IREDELL COUNTY HEALTH DEPARTMENT

IMPROVEMENT PERMIT / AUTHORIZATION TO CONSTRUCT / OPERATION PERMIT / EXISTING SYSTEM INSPECTION

PERMIT# 128527 PIN# 3793-55-4485 DATE 7/2/05

SUBDIVISION AUGUSTA ACRES BLOCK / SECTION LOT 6 LOT AREA 1.566 SITE CLASS PS DESIGN FLOW 480 L.T.A.R. 13

INITIAL SITE SKETCH

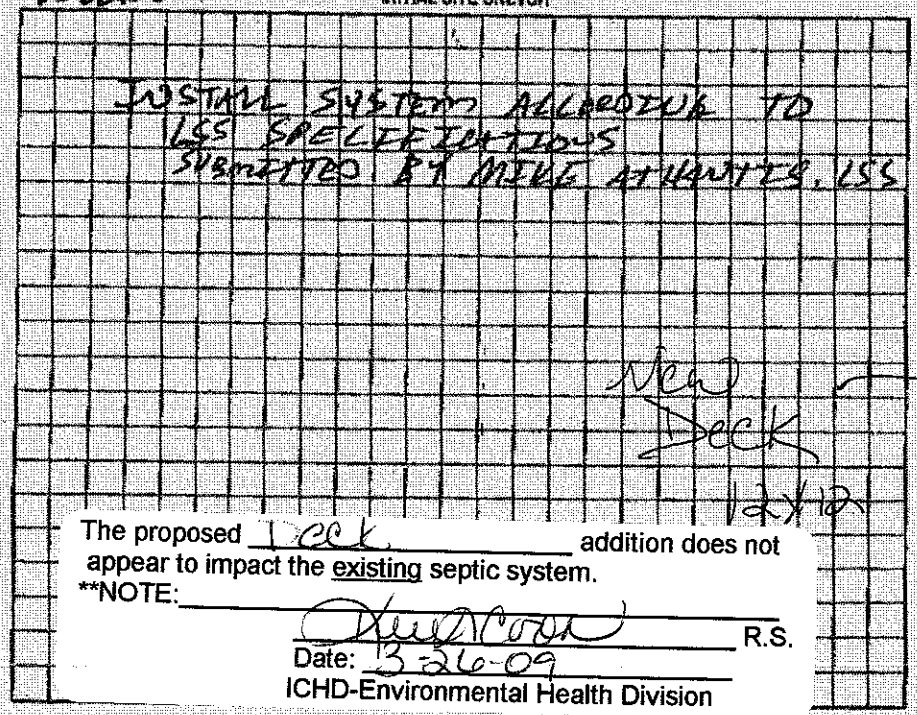
Comments/Conditions: ① ROAD NOT CUT IN AT TIME OF CHECK. MAINTAIN SETBACKS OR PERMIT WILL BE VOID. ② 1 SPOT WAS 12% SLOPE, LOOSE 5" TOLERANCE TO OF 19" ON THE BLOW SIDE. DUE TO THIS BE CAREFUL DURING DISTURB.

Comments/Conditions: ③ LSS SUBMITTED PLAT SHOWING ABANDONED WELL 60' FROM 1ST TRENCH UPSLOPE. WILL later SUBMIT WELL DISMANTLEMENT, but WELL is abandoned. *SETBACK IS MAINTAINED* TO FUTURE PROPERTY LINE

AS BUILT SKETCH

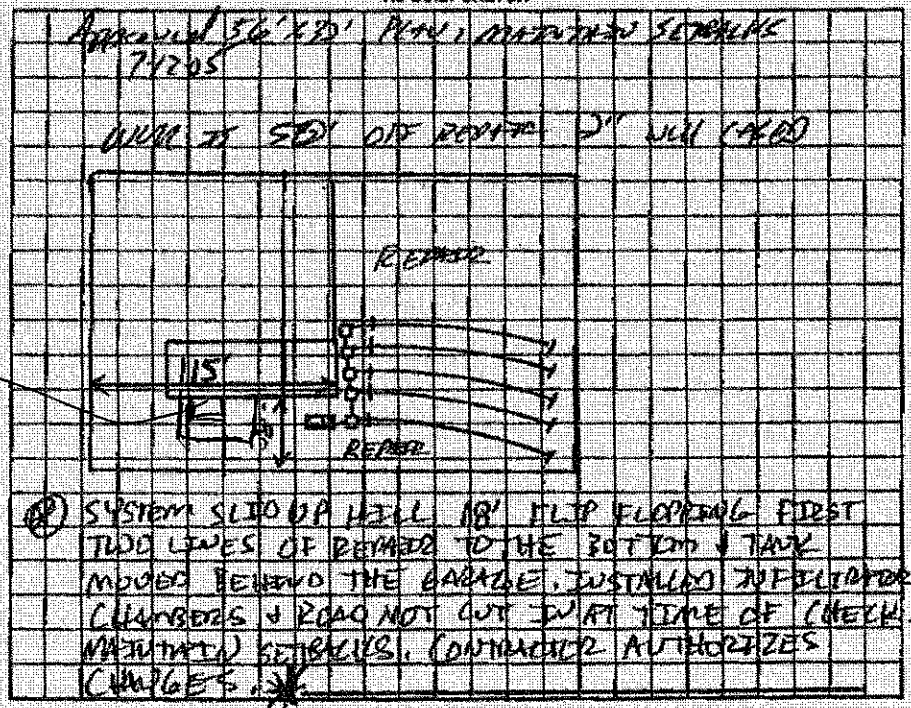
The proposed Deck addition does not appear to impact the existing septic system.
**NOTE:
R.S.
Date: 3-26-09
ICHD-Environmental Health Division
